SHENSTONE PARK PSP - PANEL HEARING

Acoustic Evidence

SLR Ref: 640.11432-R01
Version No: -v1.0
October 2020

Figure 1 PSP Plan 15 - Buffers

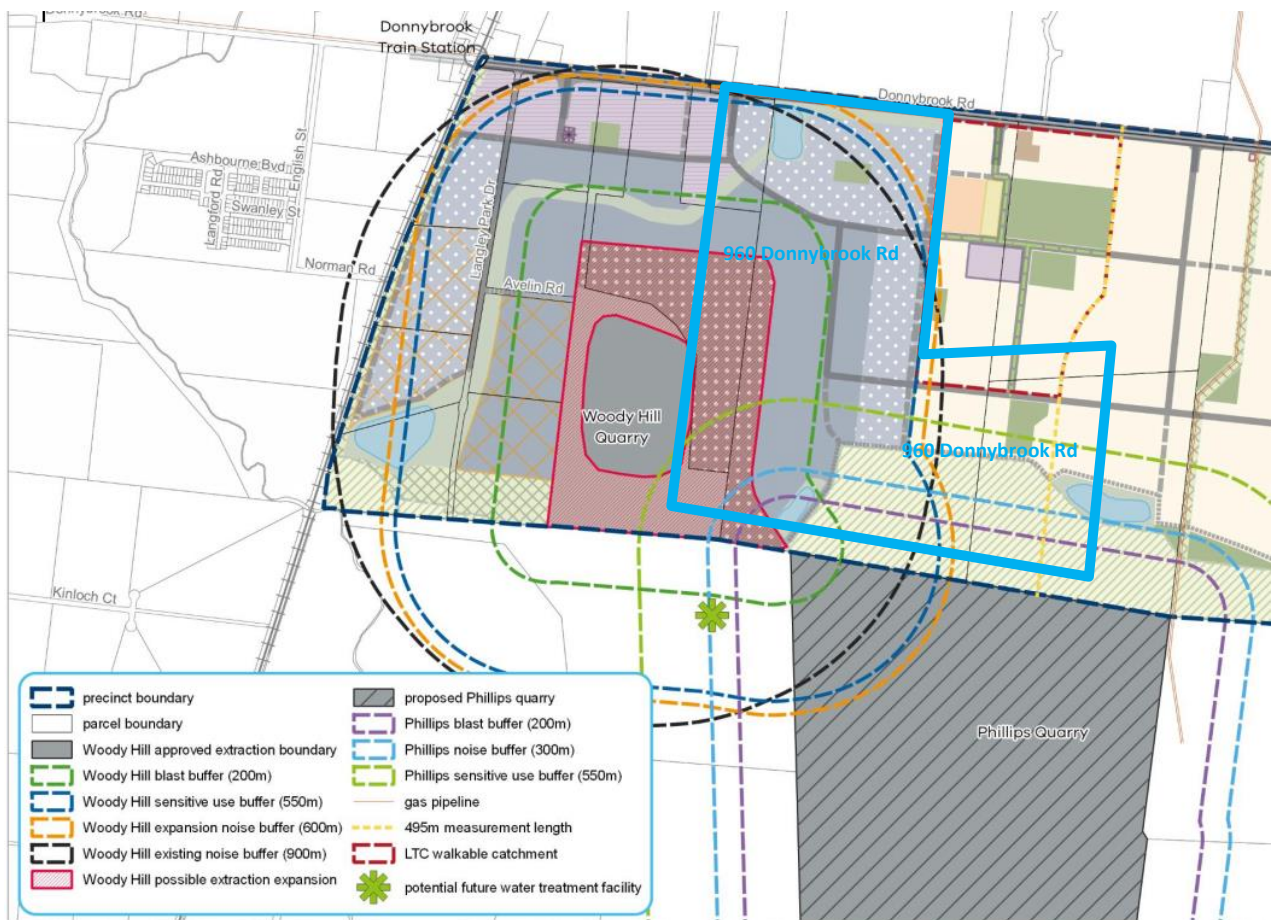
10. The above indicates a possible expansion of the Woody Hill Quarry into 960 Donnybrook Road. It has been confirmed by Barro Group (the operator of the Woody Hill Quarry) that there are no rights to carry out the indicated extraction expansion into 960 Donnybrook Road and the existing Woody Hill Quarry work authorities only extend to the boundary of the two properties.
11. The buffers in relation to noise / amenity impacts were developed based on the GHD Quarry Impact Assessment report. I provide below a high level review of this report.

Figure 2 Excerpt from GHD Quarry Impact Assessment Report Appendix D (29 and 30 August 2017 Noise Logging Results)

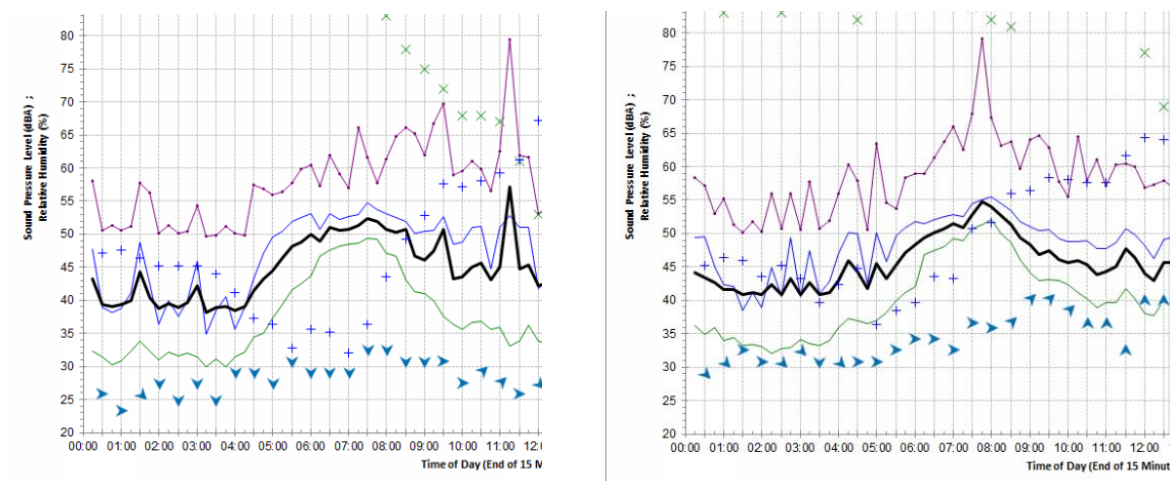
17. There is a critical error in how the night period background levels have been analysed. The night period background levels have been based on averaging of the entire night period background data (from 10 pm to 7am). This is not appropriate for the subject quarry operations. The background level is meant to be determined only for the periods which the industry operates. In the case of the quarry operations, the only night period operations are from 6 am to 7 am, and this should be the only hour used for determining the night period noise limits. The definition of 'background level' from SEPP N-1 is reproduced below, with the key aspects relating to the above underlined.

18. The 6 am to 7 am period often represents elevated background levels in many situations compared to the rest of the night as traffic and general activity builds up during this time. This can be clearly observed in Appendix D of the GHD Report noise logging results, which shows a significant ramp-up of background levels typically starting from 5 am, from Monday to Saturday. An example extract from two weekdays is provided below. The green line represents the 15 minute 'L90' level which is the parameter used to define background level. By 6 am, it can be observed there is a significant increase (10 to 15 dBA) compared to earlier in the night.

19. I re-analysed the data from the Appendix D graphs to obtain an estimate of the 6 am to 7 am background levels and determined a value of 45 dBA, L90 (based on typical lowest 6 am to 6.15 am data). This is significantly higher than the adopted 28 dBA background level used in the GHD report based on the quietest all-night background level. The implications of this difference are significant, with noise limits being increased to 48 dBA for the night operations, compared to 37 dBA as adopted in the GHD report.
